Egley Road
Responses to ES Review (Final)
May 2020

EGLEY ROAD – ES REVIEW RESPONSE TABLE

An Environmental Statement was submitted on 4 December 2019 for the Egley Road Proposed Development (Planning Ref PLAN/2019/1177). An EIA Scoping Report to determine and agree the scope and methodology of the Environmental Statement was submitted on 24 May 2019 and an EIA Scoping Opinion was received from Woking Borough Council (WBC) on 9 August 2019. The Environmental Statement was based on the EIA Scoping Opinion.

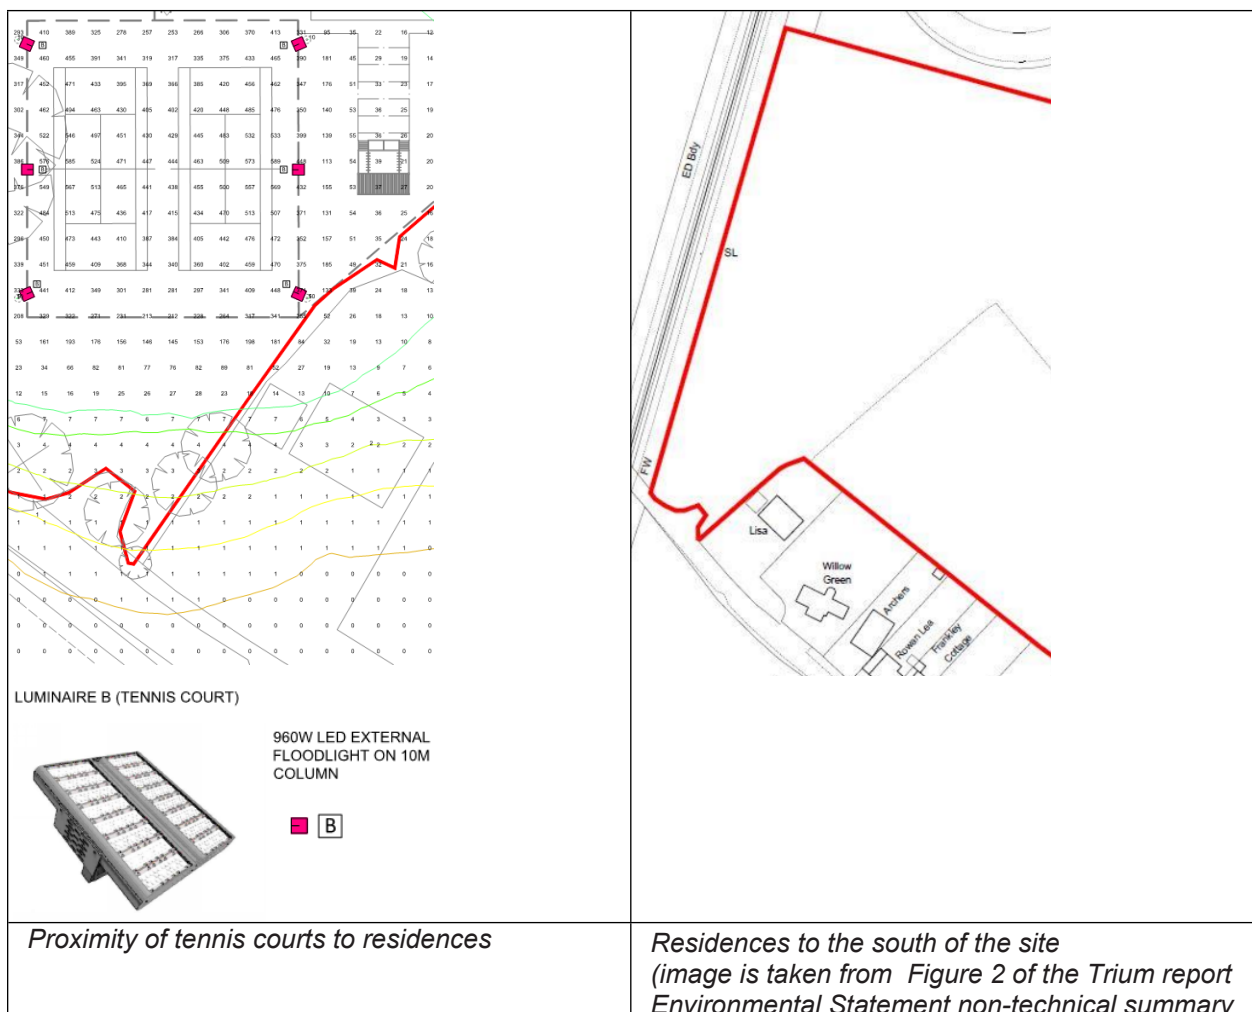
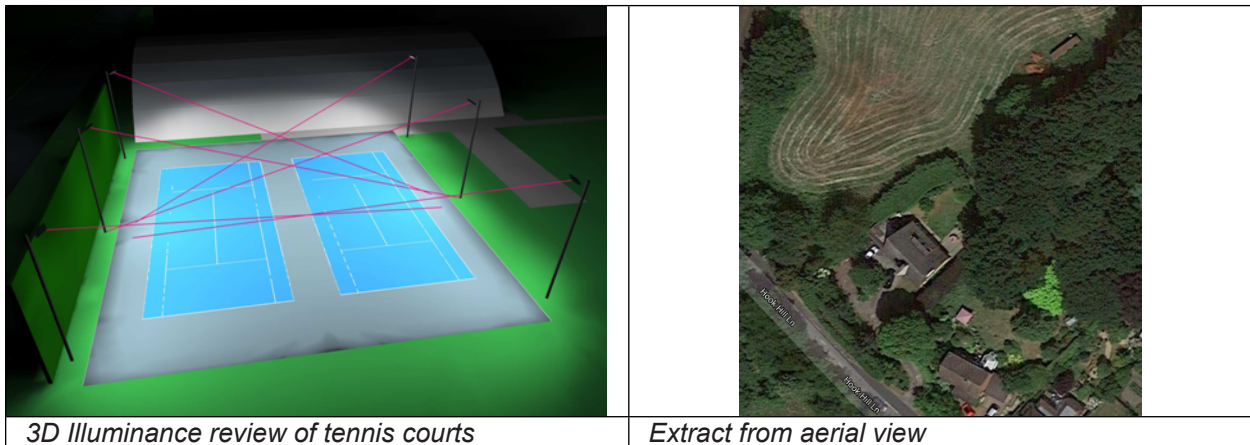
The drawing and supporting drawings indicate that there is floodlighting to the tennis courts, which are in close proximity to adjacent properties.

Lighting plots are provided which show lux levels on the floor however there are no lighting calculations that indicate the following related to reduction of obtrusive light in accordance with Table 2 of the Institute of Lighting Professionals Guidance Notes for the Reduction of Obtrusive Light GN01:2011 for the following:

- Sky glow – *upward light ratio of the installation.*
- Light intrusion into windows – *vertical illuminance in Lux measured flat on the glazing at the centre of the window.*
- Luminaire intensity – *of the luminaires in the potentially obtrusive direction, outside of the area being lit.*
- Building luminance – *buildings directly illuminated as a night-time feature.*
 - Not relevant for this assessment as no feature lit buildings are in the area of interest.

The images below indicate that the adjoining properties of Lisa, Willow Green and Archers could be affected by obtrusive light from the tennis court floodlighting.

Lighting calculations should be provided that show compliance with Table 2 of the Institute of Lighting Professionals Guidance Notes for the Reduction of Obtrusive Light GN01:2011 for the following:

In order to ensure that these effects are fully addressed, we suggest the following planning condition:

Evidence will be provided to show that the external lighting design is in line with recommendations with the Guidance Notes for the reduction of Obtrusive Light GN01:2011 for Environmental Zone E3, with regards to sky glow, light intrusion into residential windows and luminaire intensity.

We consider their response suggested as a Planning Condition is appropriate.

Figure 1 – Proposed Pedestrian Crossing Improvements – Egley Road /Hoe Valley School Junction

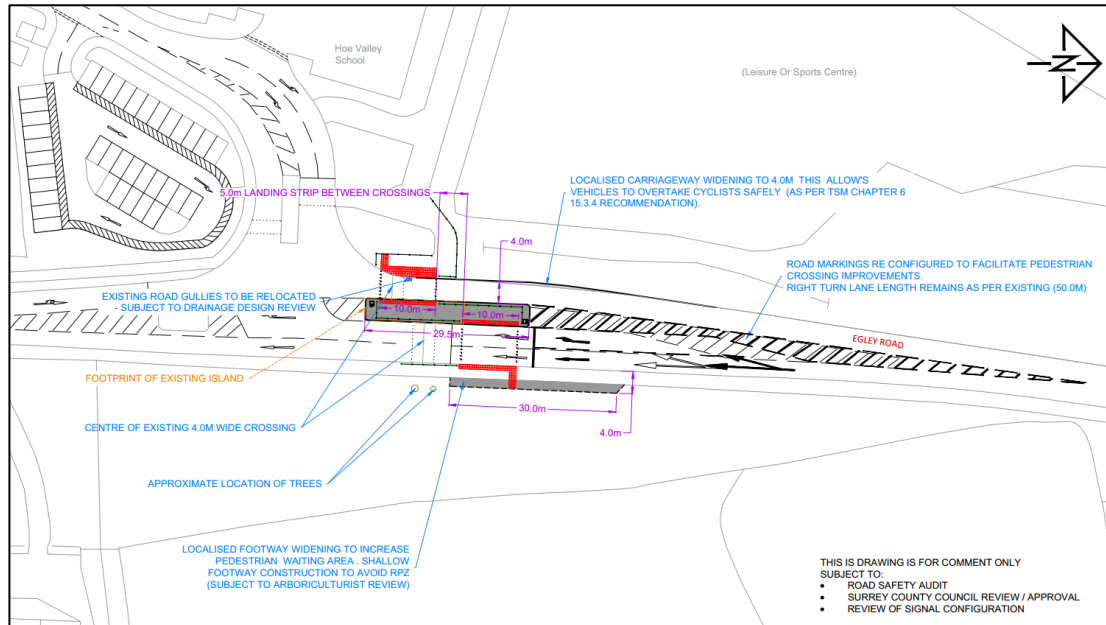
- The signal controlled crossing at the junction between Egley Road and Hoe Valley School is at capacity during the school peak times. As the development is proposing to increase pedestrian movements at these times, improvements to the crossing are required. This involves lengthening the island on the northern arm, and relocating the crossing location further north, away from the oak trees, and widening the footway slightly at the crossing point on the eastern side of the road. The Transport Development Planning Team would like to work together on drawing up plans and identifying a possible solution to this.
- Can the figures for the hour before the PM peak period please be provided (4-5pm), which is the Hoe Valley School peak.
- Queue length validation reports need to be submitted for the junctions that have been assessed.

5. SCC raised the concern that the controlled crossing on Egley Road and Hoe Valley School is at capacity during the school peak times. Additional pedestrians accessing the proposed development may cause this crossing to operate over capacity.
6. Vectos, in consultation with SCC, has designed a scheme which will improve the pedestrian capacity. **Figure 1** shows the design of the proposed crossing improvements. A scale drawing of this proposal is provided at **Appendix B**.

7. The proposals account for a 29.5m crossing in length, with two 10m crossing areas on either side of the road. The eastern footway alongside Egley Road is to be widened to 4m to increase the pedestrian waiting area. This will improve the environment for all pedestrians in this location and effectively mitigate the impact of the proposed development. Additionally, the northbound carriageway will be increased to 4m in width to allow for vehicles to overtake cyclists safely.
